NFPA Technical Committee on Chimney, Fireplaces, and Venting Systems for Heat-Producing Appliances (CHI-AAA) NFPA 211 Second Draft Meeting (Annual 2023)

September 12th, 2022
1:00 p.m. – 5:00 p.m. (Eastern)

Attachment: NFPA 211 Public Comment Report

**Public Comment No. 6-NFPA 211-2022 [Section No. 9.7.9]****9.7.9**

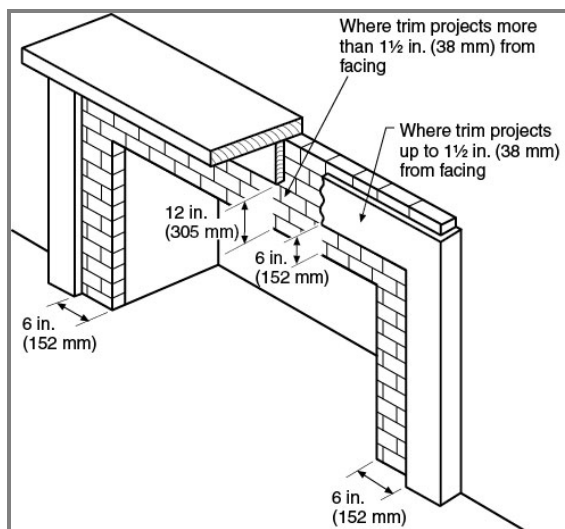
Connectors shall be supported, and connector joints shall be fastened using sheet metal screws, rivets, banding or strapping, or other approved means.

- The use of a so-called “friction-fit” or “slip-fit” to attach a connector to the flue collar of a heating appliance at the “connector joint” should never be permitted

- The use of “slip-fits” and “friction-fits” only to attach the connector to a flue collar on a heating appliance is inherently dangerous and unnecessarily poses the risk of exposing occupants of the structure being heated to the release of carbon monoxide or other toxic gases in the event the connector becomes detached or loosened from the flue collar

- No other person should die in the fashion my mom did for the lack of a few sheet metal screws and/or a couple of pieces of metal strapping

- Connectors that are not securely fastened to a flue collar with screws, rivets, strapping or other approved means are at **significant** risk of becoming detached from the flue collar as a result of a delayed-ignition event, vibrations from operation of the heating appliance or some external source, or the connector being moved or bumped into including accidentally
